## **STAFF MEMORANDUM**

**Date:** August 10, 2022  
**To:** Planning Board  
**From:** Camille Pattison, NRPC Assistant Director  
**Subject:** **Case SD2022-07 and SP2022-07 Ron and Loreen Racicot, Map 14 Lot 10 and Map 14 Lot 10-1, 21 Old Wilton Road**

# LOT LINE ADJUSTMENT AND SITE PLAN AMENDMENT

TAX MAP 14, LOT 10-1 - 21 OLD WILTON ROAD

**LOT LINE ADJUSTMENT PLAN**  
**INDUSTRIAL DEVELOPMENT**  
 TAX MAP PARCELS 14-10 AND 14-10-1  
 (21 OLD WILTON ROAD)  
 MILFORD, NEW HAMPSHIRE  
 PREPARED FOR AND LAND OF:  
**RONALD L. & LOREEN M. RACICOT**  
 70 PUTNAM HILL ROAD, LYNEBOROUGH, NH 03082-6134.

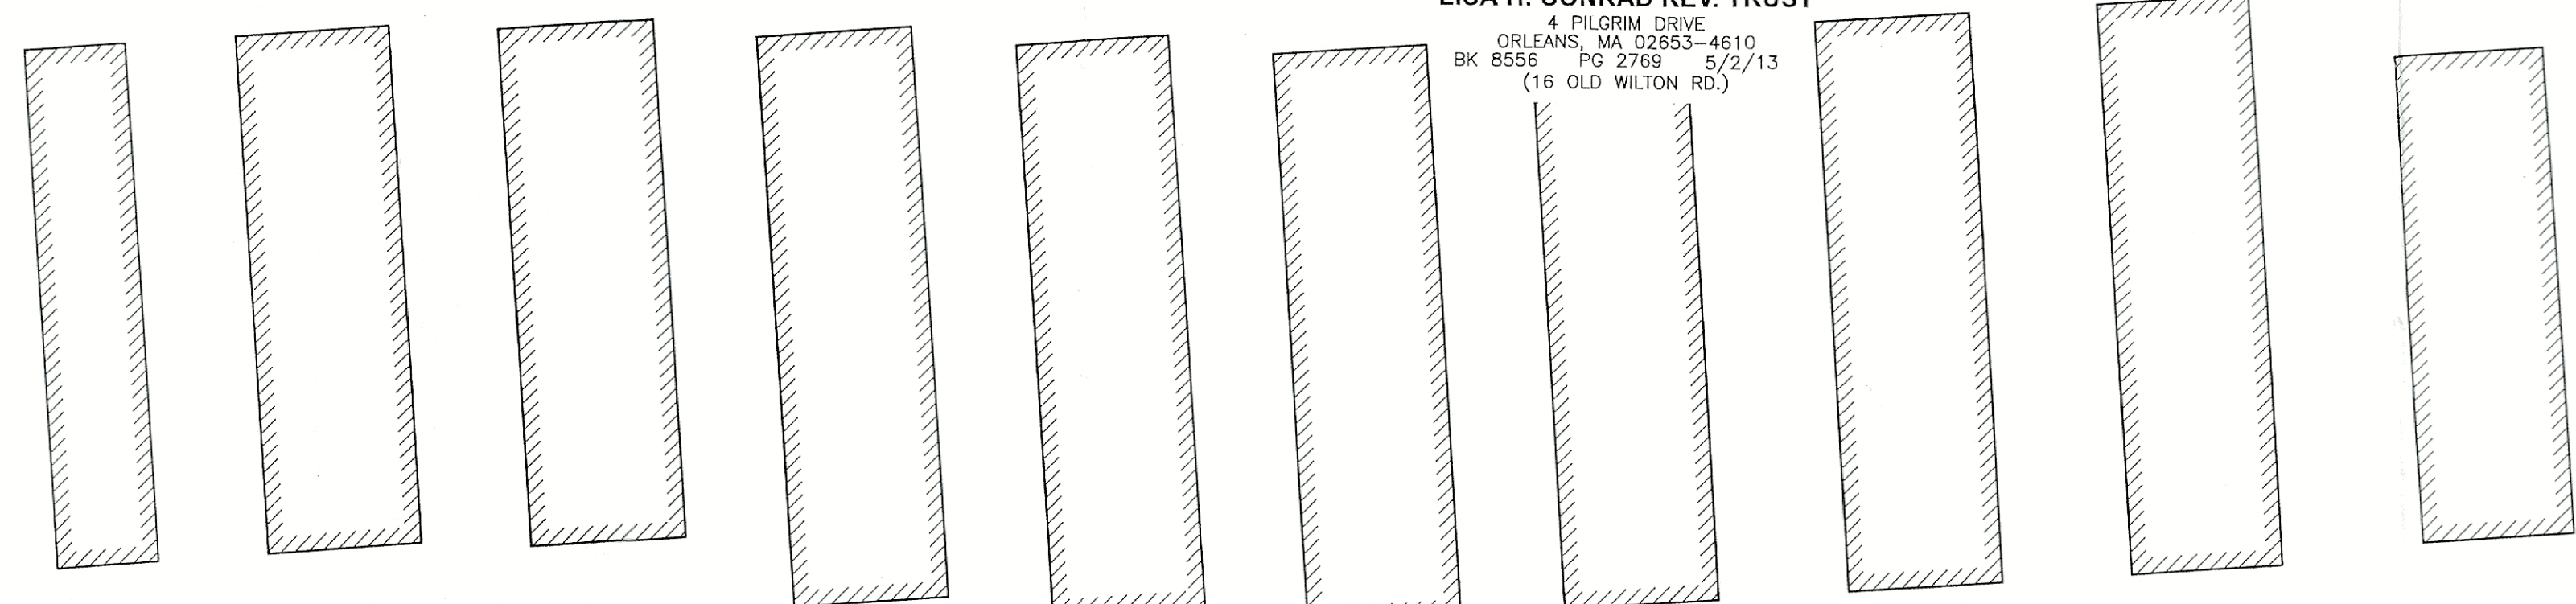
1. The plan will need to be amended to show a bound for the southeast corner of Map 14, Lot 10.-1.
2. A note shall be added to the plan stating that prior to the signing of the plan, all monumentation shall be set and noted on the plan or a security be provided to the Town to cover the cost of monumentation.

6. The applicant shall submit copies of the proposed 1,250 s.f. drainage easement and 1,210 s.f. driveway turnaround easement to the Office of Community Development for review and approval prior to the plans being signed by the Board.
